Service Bulletin

NOTIFICATION OF PRODUCT IMPROVEMENT (MINOR CHANGE) FOR THE PART NUMBER 1-002-0102-2173 STATIC INVERTER

1.0 Aircraft Effectivity: ATR 42/72

SB 1-002-0102-2173-24-29

FIGURE 1: MOD LEVEL LOCATION

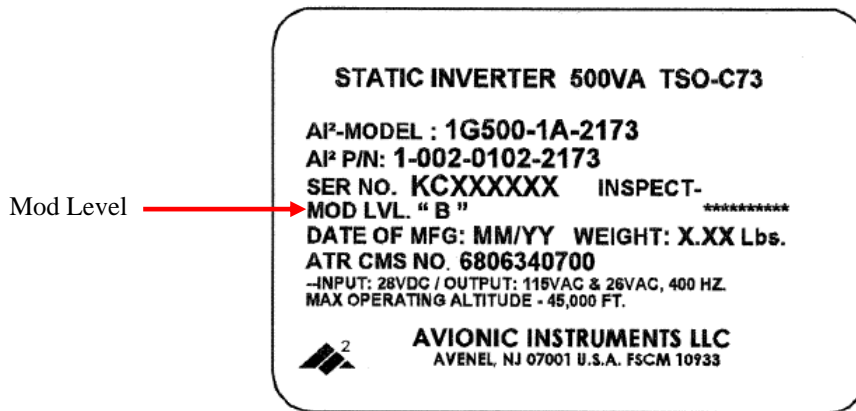
12.1 Upon completion of the modification, the label on the top panel will be changed to indicate MOD LVL. "B" (see Figure 1).
